To: Interested Agencies

The following Updated Traffic Study has been filed with the Sonoma County Permit and Resource Management Department.

File Number: PLP05-0009
Applicant Name: Henry Belmonte
Owner Name: Vittorio and Henry Belmonte
Site Address: 9125 Highway 12, Kenwood
APN: 050-272-028

To:	Mr. Blake Hillegas, Supervising Planner County of Sonoma Permit & Resource Management Department	Project:	Peer Review (#2) of Traffic Impact Study for the VJB Vineyard and Cellars
From:	Peter Galloway, Senior Transportation Planner	Ref/Job No.:	County Project PLP05-009 GHD 11145104
CC:	Todd Tregenza, AICP Kamesh Vedula, T.E., P.E.	File No.:	C2046MEM006.docx

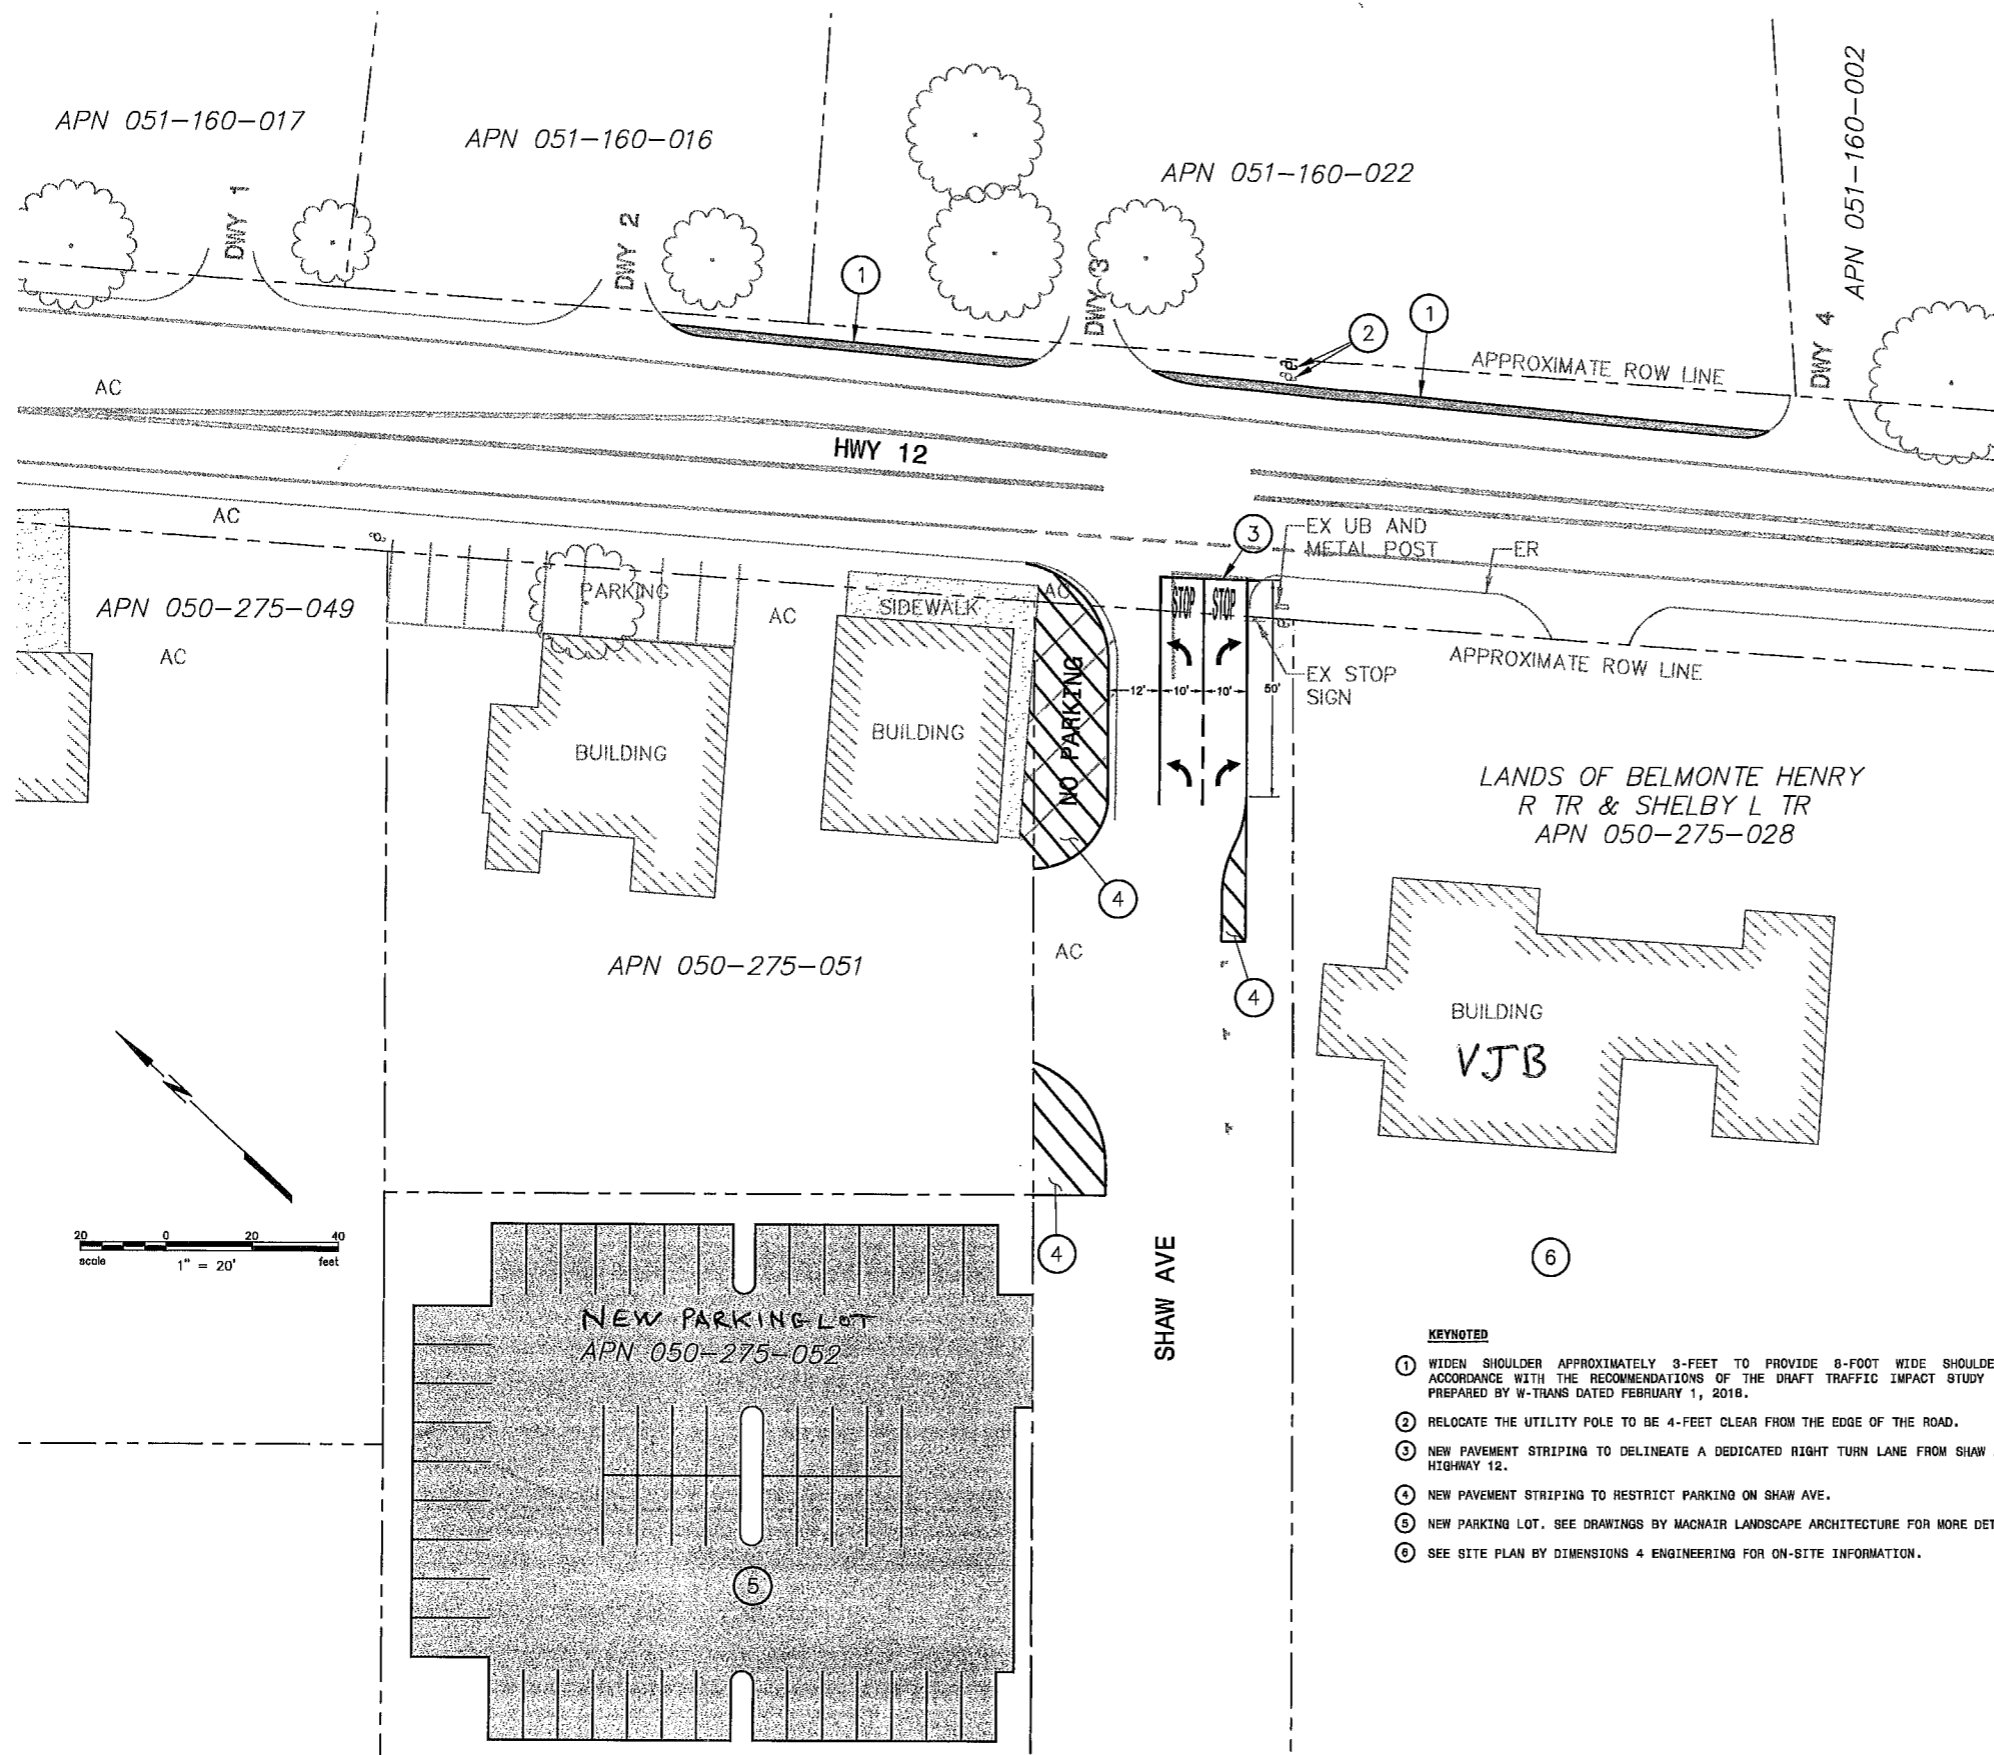
It is unclear how the 8' shoulder widening that is being proposed would differ from the widening required to provide a left turn pocket without an accompanying visual. It appears that 8' shoulders are already present along this section of SR 12. Currently, vehicles pre-position for left turns from SR 12 onto Shaw Avenue by crossing double yellow lines and staging in the 6'-wide "transition" striping between Shaw Avenue and the turn pocket on SR 12 at Randolph Avenue.
